Project	IEEE 802.16 Broadband Wireless Access Working Group < http://ieee802.org/16 >	
Title	Supplementary Changes for Comment #30 in 802. 16-04/20	
Date Submitted	2004-05-04	
Source(s)	Lei Wang Wi-LAN Inc. 2891 Sunridge Way, NE Calgary, AB, Canada, T1Y 7K7 Jonathan Labs Wavesat Wireless, Inc.	Voice: (403)273-9133 Fax: (403)273-5100 Email: LeiW@wi-lan.com
Re:	This is a contribution to IEEE 802.16-REVd.	
Abstract	This contribution describes the proposed changes to not have multiple UL channels for a DL channel in 802.16REVd.	
Purpose	To remove the unnecessary complexity in 802.16 systems.	
Notice	This document has been prepared to assist IEEE 802.16. It is offered as a basis for discussion and is not binding on the contributing individual(s) or organization(s). The material in this document is subject to change in form and content after further study. The contributor(s) reserve(s) the right to add, amend or withdraw material contained herein.

Supplementary Changes for Comment #30 in 802.16-04/20

4. Proposed Changes

Figure 56—Obtaining uplink parameters

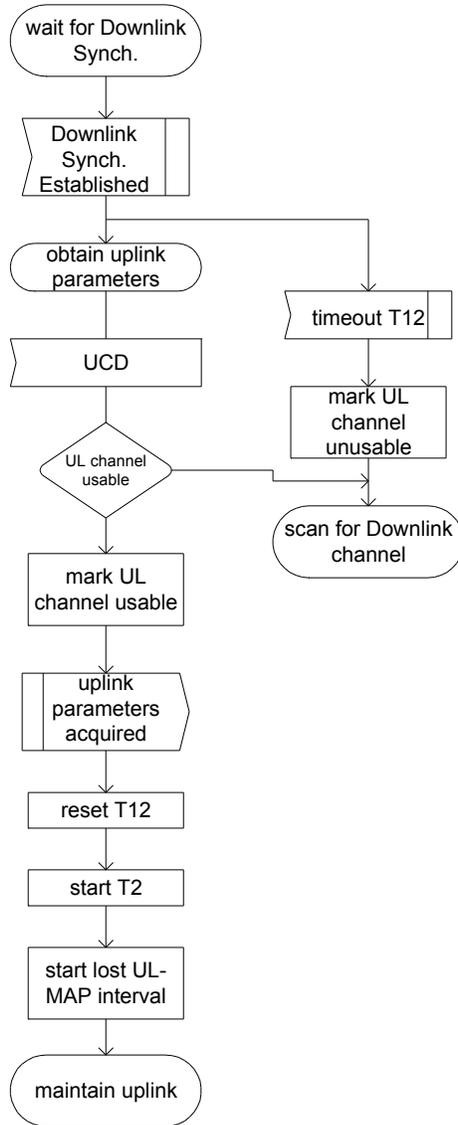
~~The SS shall collect all UCDs which are different in their channel ID field to build a set of usable channel IDs. If no uplink channel can be found after a suitable timeout period, then the SS shall continue scanning to find another downlink channel. The process of obtaining uplink parameters is illustrated in Figure 56.~~

Figure 57—Maintain uplink parameters, ~~single uplink case, ChID=i~~

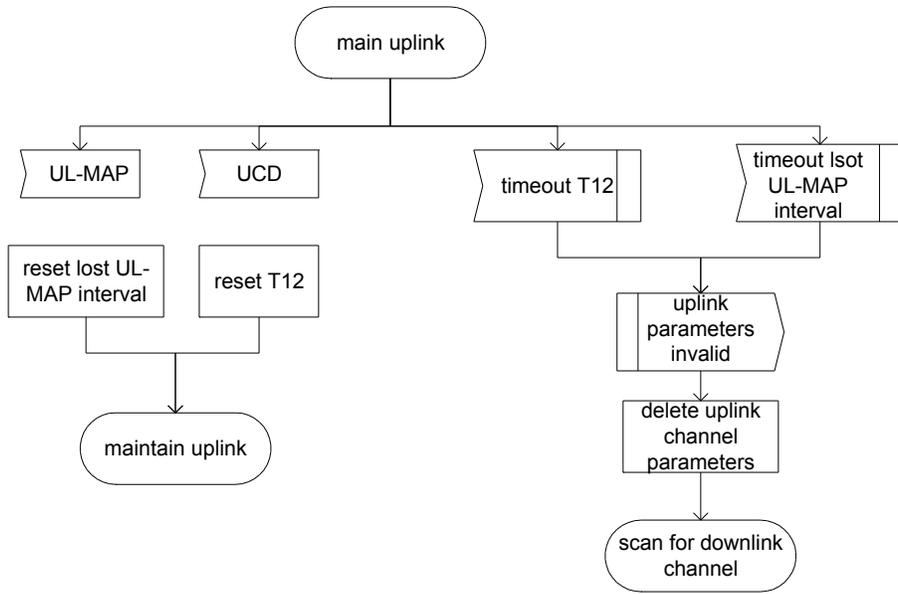
The SS shall perform initial ranging at least once, per Figures 58 and 59. If initial ranging is not successful, ~~then the next channel ID is selected, and~~ the procedure is restarted from ~~UCD extraction scanning to find another downlink channel~~. ~~When there are no more channel IDs to try, then the SS shall continue scanning to find another downlink channel~~. The SS MAC is considered to have valid uplink parameters as long as it continues to successfully receive the UL-MAP and UCD messages. If at least one of these messages is not received within the time intervals specified in Table 295, the SS shall not use the uplink. This is illustrated in Figure 57.
